**Transport**  
Roads & Maritime  
Services

# **FAUNA CONNECTIVITY REPORT (TABLE 6.2)**

## **Oxley Highway to Kundabung**

**DECEMBER 2014**

# Culvert CH 22160, CH 22170 and CH 22320

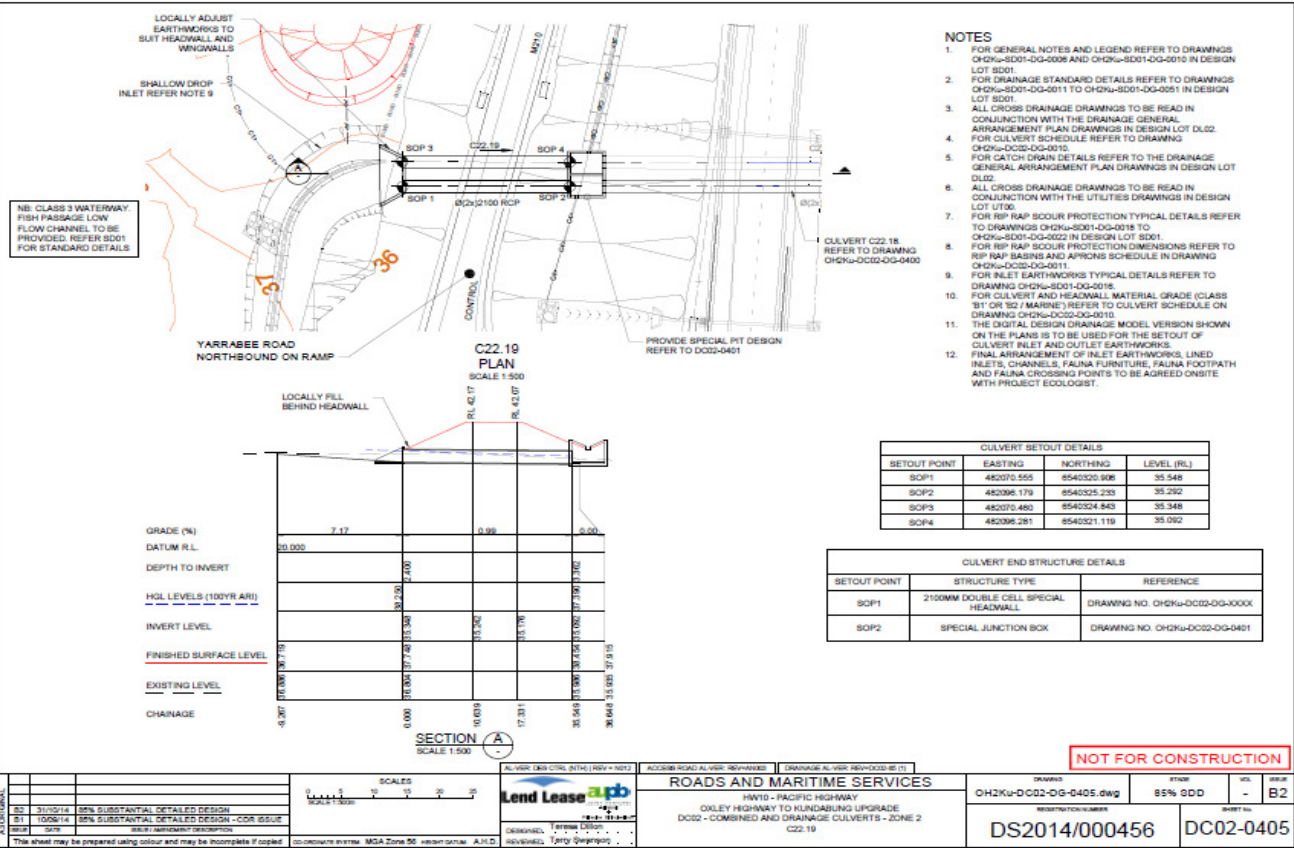
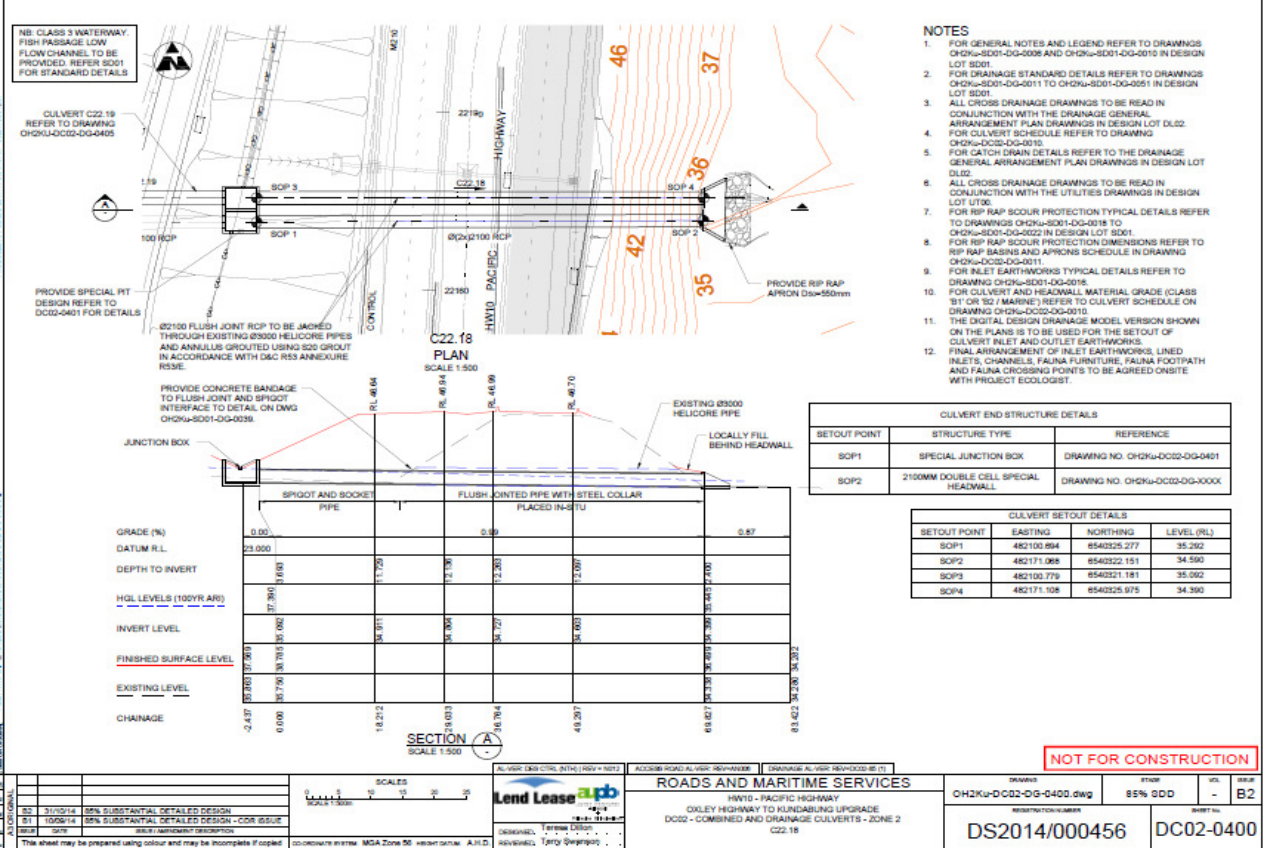
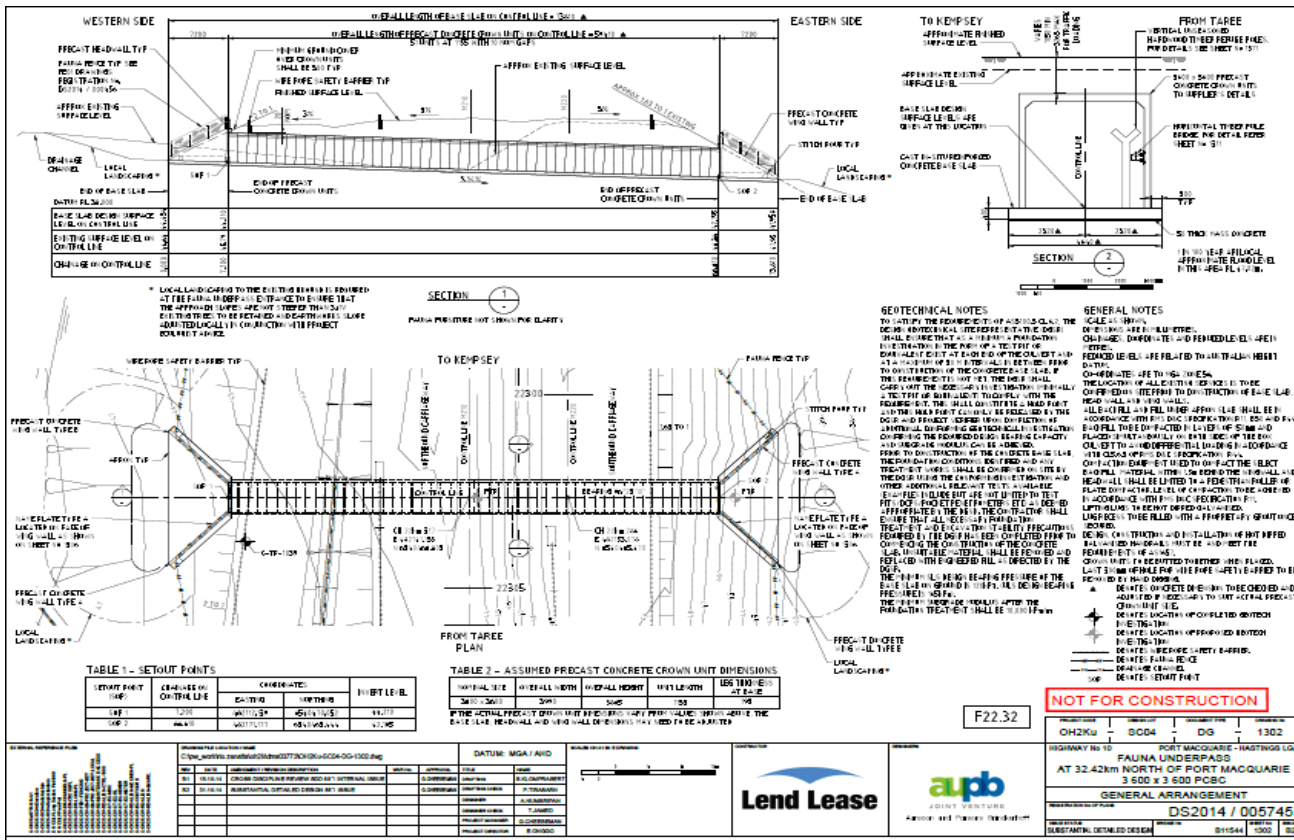
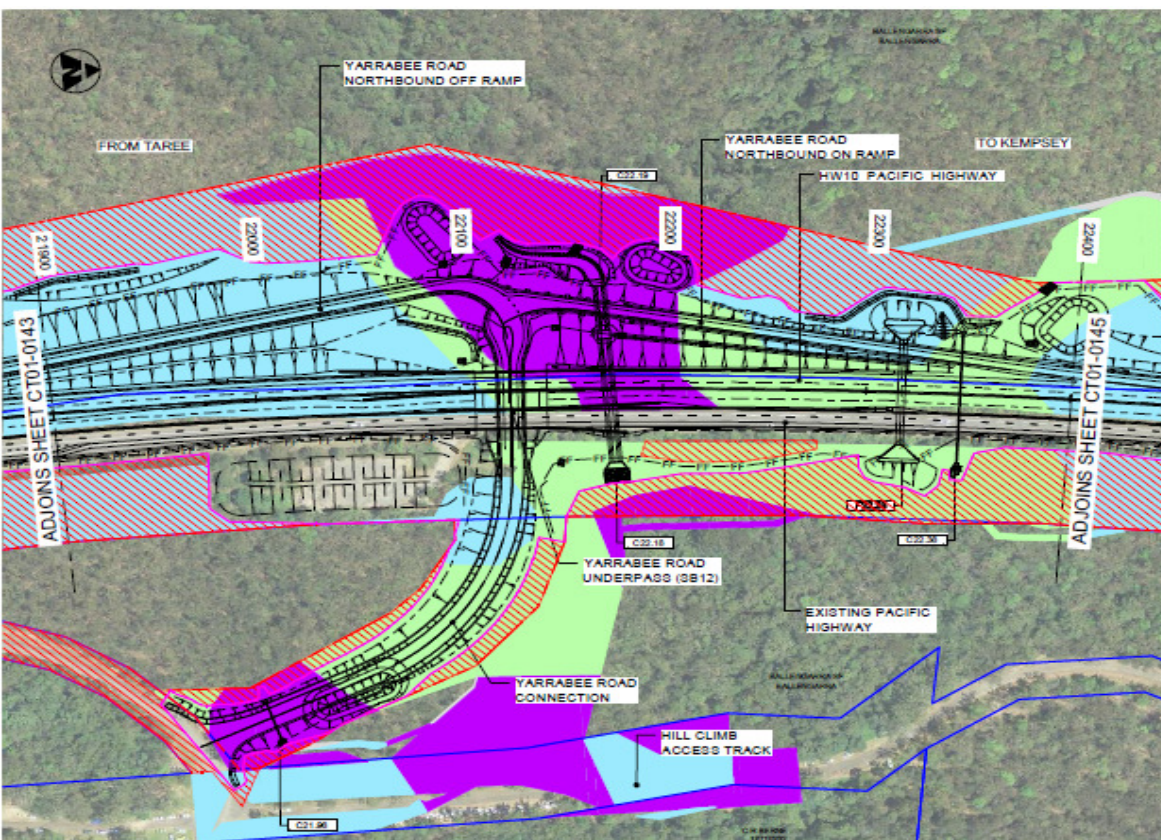
C22.18	Incidental (box culvert)	22180	1 cell 1.5 x 1.5 RCBC	Overall length 72.0m	Incidental, fish passage	22160	cell 2100mm dia RCP	Overall length 69.8m	No	No	Located in a mapped regional corridor linking areas of key habitat to the east and west	neutral	Neutral
C22.19			1 cell 1.5 x 1.5 RCBC	Overall length 28.0m	Incidental, fish passage	22170	2 cell 1800dia dia RCP	Overall length 25.7m	No	No	Located in a mapped regional corridor linking areas of key habitat to the east and west	neutral	Neutral
F22.32	Dedicated	22300	1 cell 3.6 x 3.6 RCBC	Overall length 60.0m	Dedicated	22320	no change proposed	Overall length 59.4m	Upstream 1:4; None required downstream.	Install rail and refuge poles (every ~15m)(koalas); install refuge poles at entry and exit to culvert; rocks & logs (frogs/reptiles/small mammals); Install hollow logs outside near entry/exit (quolls).	Located in a mapped regional corridor linking areas of key habitat to the east and west	Neutral	Regrade should be extended to 1 in 4 on the upstream. Agreed commitments to drainage must still apply to F22.32.

<b>Location: F22.32</b>	
Crossing type:	Dedicated
SWTC Table 6.2 location(s)	CH 22300
SWTC Table 6.2 Structure form(s)	Box culvert
SWTC Table 6.2 dimensions(s)	1 Cell, 3.6m wide x 3.6m high
Original location vegetation	Moist Gully Forest (NB) Moist Slopes Forest (SB)
Watercourse	N/A
Connectivity value	Very high- in an area of mapped regional corridor
Proposed location	CH 22320
Proposed structure	Unchanged
Proposed dimensions	Unchanged
New location vegetation	Moist Gully Forest (NB) Moist Slopes Forest (SB)
Reason for design change	The move of 20m was to combine two culverts (F22.32A and F22.32B) and reduce the overall length of the fauna passage by around 20 metres.
Engineering considerations:	N/A
Ecological outcome:	Neutral biodiversity outcome.
Fauna exclusion fencing provisions	<p>Fauna fencing is located around the highway formation at this location. Fencing will be located over the top of the headwall of the crossing allowing this culvert to be used by fauna. Rails and refuge poles as originally identified will still be provided</p> <p>Drop down structures will be provided in locations in close proximity to the underpass, as agreed with the project ecologist and confirmed onsite with OEH.</p>

Culvert ID	Stn	Type	Change <sup>1</sup>	Comment(s)
66/C22.18	22180	Incidental	<p>Downsized from combined to incidental.</p> <p>Culvert split from one 76.8m culvert to two culverts, one 72m under the main carriageways, and one 28m under the northbound on ramp.</p>	<p>Downgraded to drainage only (incidental culvert) due to proximity of dedicated fauna culvert.</p> <p>Dedicated crossing structure located 120m to the north at 22300 and Yarrabee Rd under bridge (80m south) widened to provide greater fauna movement and dry passage opportunities.</p> <p>Changed layout of the Yarrabee Interchange, to address safety issues, resulted in the need to split the culvert to maintain adequate fauna passage provisions.</p> <p>Increased length due to increased cutting depth at this location.</p>
67F/F22.32	22300	Dedicated	<p>Relocated from 22325 to 22300 (21m south).</p> <p>Culvert split from one 48m culvert to two culverts, one 60m and one 19m under the northbound on ramp.</p> <p>Size increased from 3 x 3 metres to 3.6 x 3.6 metres.</p>	<p>Size increased as culvert at 22180 downsized and length has increased.</p> <p>Relocated to improve sight lines through culvert and ensure dry passage. Culvert remains within key regional corridor.</p>

# Culvert CH 23050

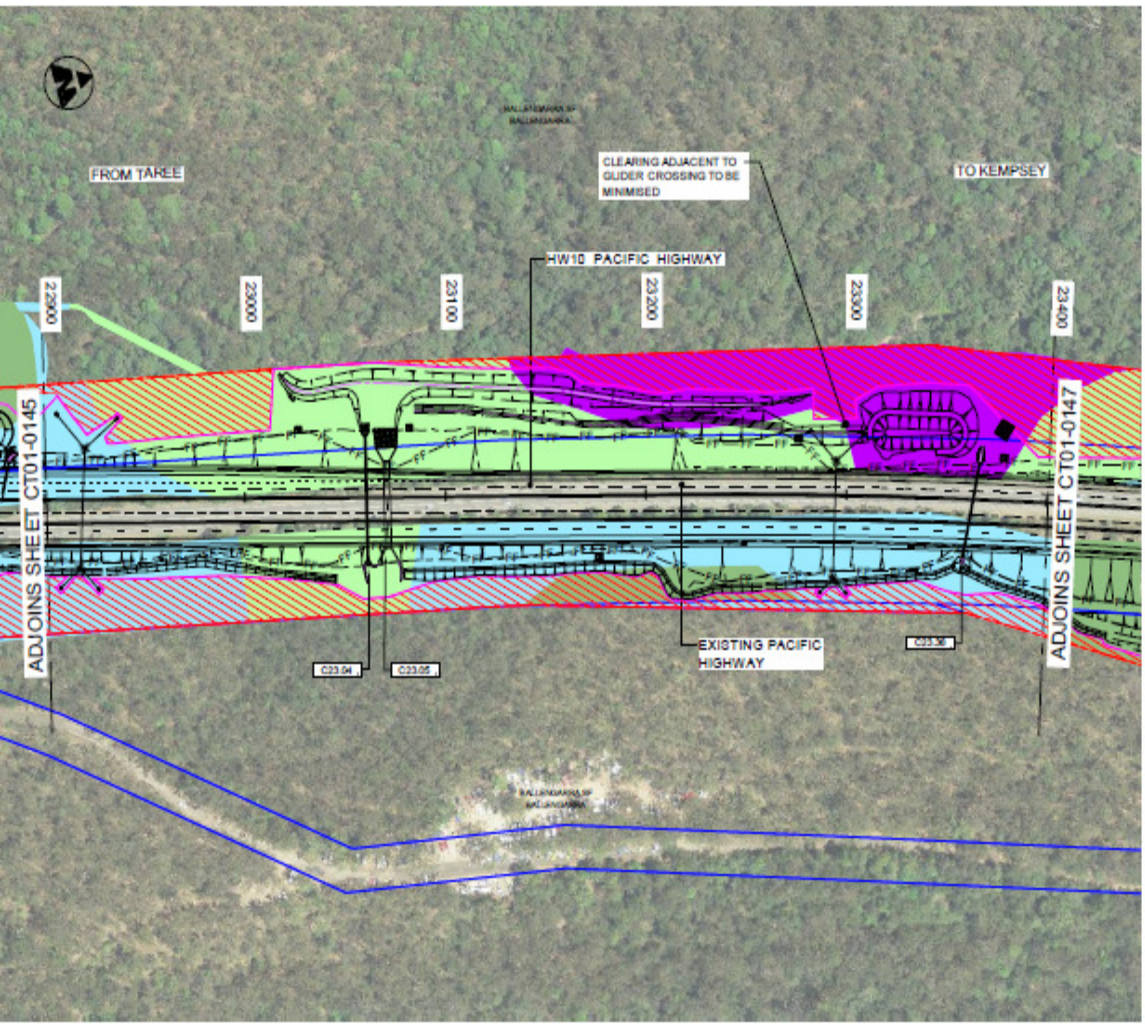
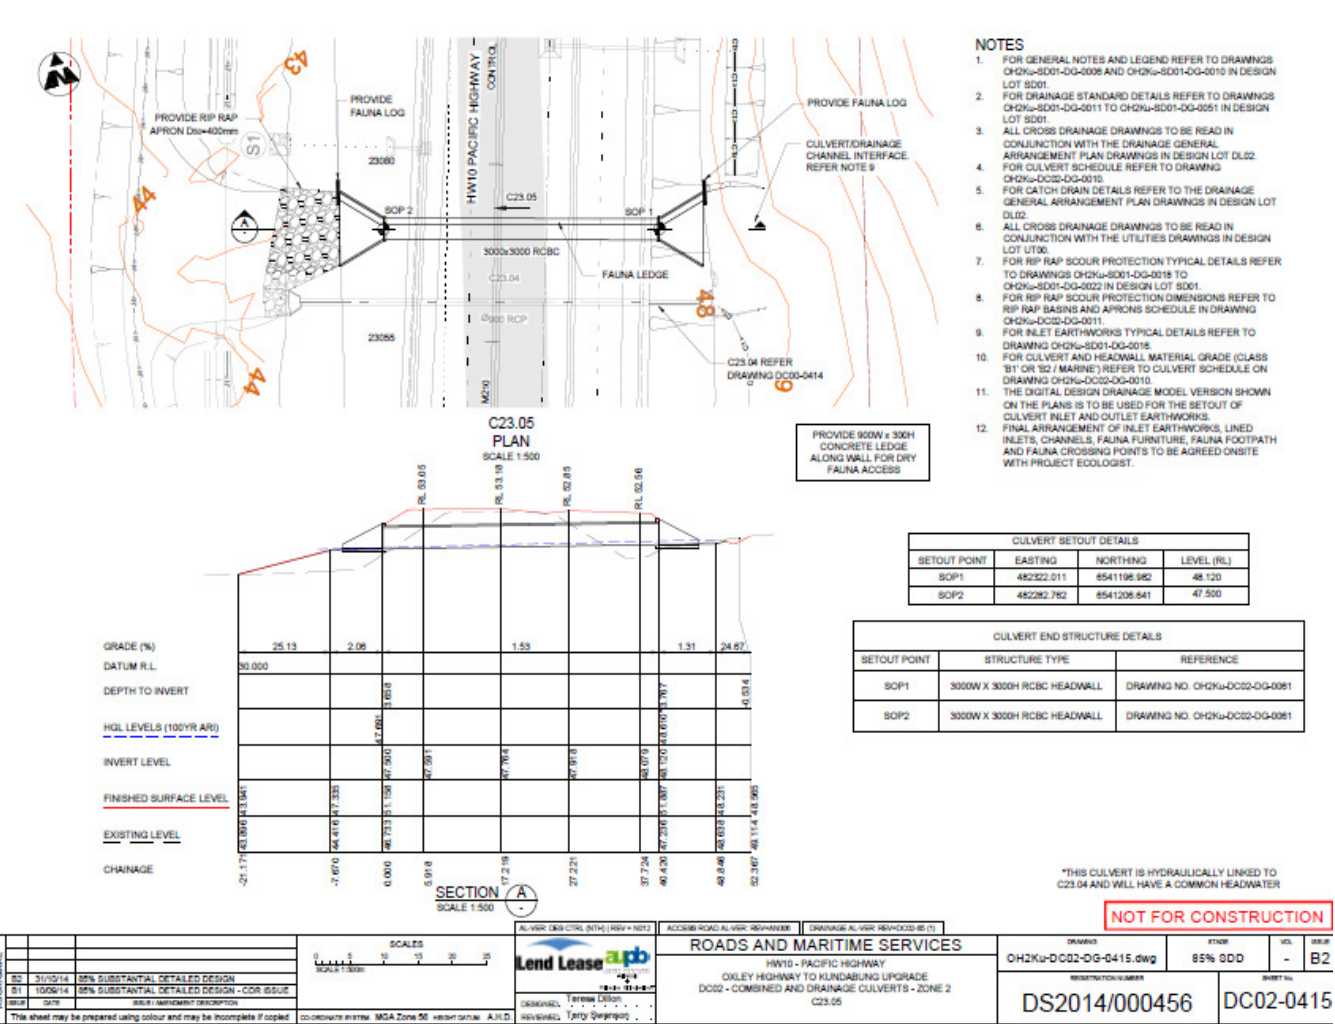
C23.05	Combined	23050	1 cell 3.0 x 3.0 RCBC	Overall length 54.0m	Combined	23060	no change proposed	Overall length 40.4m	No	Install rail and refuge poles (every ~15m) within culvert (koalas); install refuge poles at entry and exit to culvert.	Located in a mapped regional corridor linking areas of key habitat to the east and west; vegetation contiguous with mapped climate change corridor to the east	Positive	Positive
SB13	Barrys Creek twin bridges	23940	-	Overall length: 32	Barrys Creek twin bridges	23940	-	no change proposed	N/A	Rails and refuge poles (koalas); install refuge poles at entry and exit to culvert; Rocks, hollow logs (quolls)	Located in a mapped regional corridor linking areas of key habitat to the east and west; vegetation contiguous with mapped climate change corridor to the east	N/A	N/A

C23.05	23050	Combined	<p>Incidental culvert at 23050 changed to combined to accommodate fauna passage. Increased from 1.05 x 1.05 metres to 3.0 x 3.0 metres.</p> <p>Decrease in length from 55.2m to 54m.</p>	<p>Changed to combined culvert, increase in height and reduced length to provide greater opportunities for fauna passage.</p>
71F/F23.14	23140	Dedicated	Culvert deleted	Dedicated culvert has been deleted because it would exit below ground surface level, so would not function
